Subject: Main Case Oil Level Sight Glass Plug Threaded Hole Eliminated – HD Automated and Manual Models

Document Number: TAIB-1005

Date: April 03, 2023

Old Design With Sight Glass Plug Threaded Hole

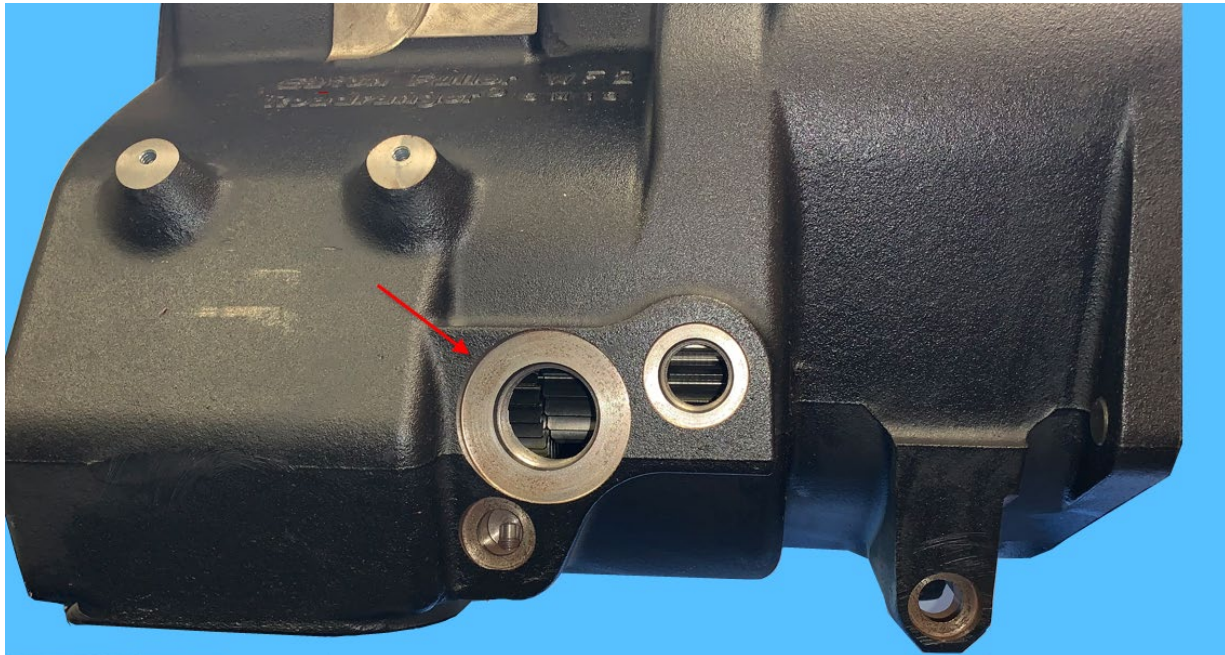
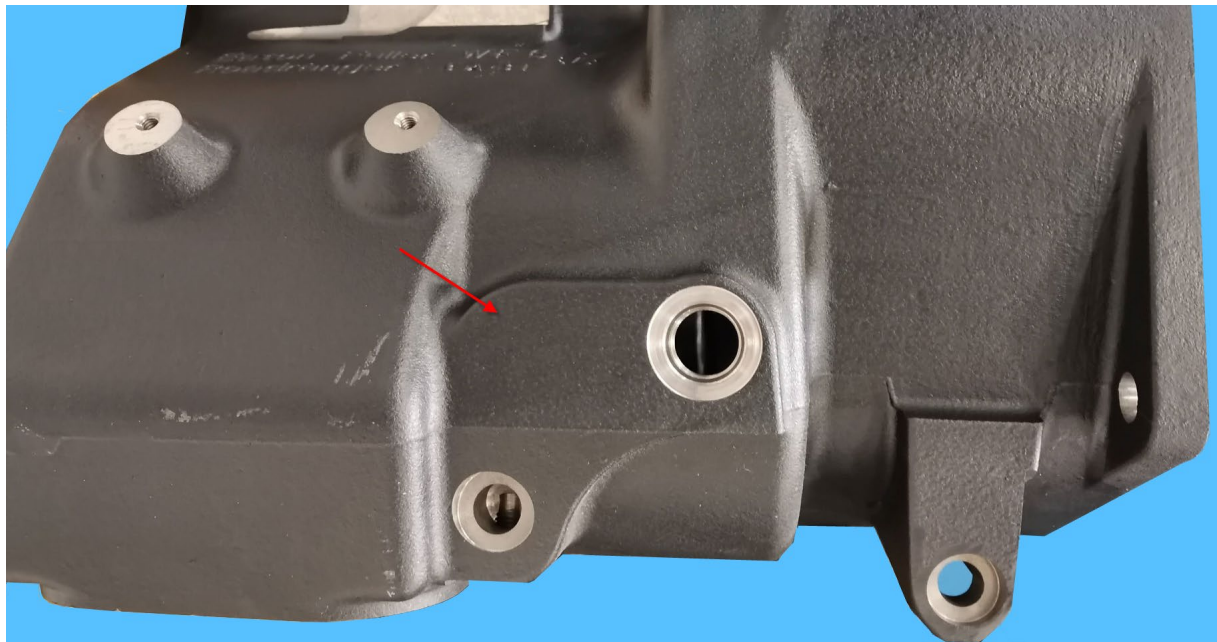
Issue Description: Redesigned Heavy-Duty transmission main cases have been released into production and service. The changes include the elimination of the oil level sight glass plug threaded hole. The oil level sight glass plug has been discontinued. This change affects all Fuller Advantage®, UltraShift® *PLUS* and RT transmission models. This will be a running change in production across the effected transmission models with completion by June 2023.

- No changes to main case part numbers. Customers will continue to order main case based on transmission model.
- No changes to transmission oil level fill procedures. Fill level is to bottom of the Fill Plug hole.
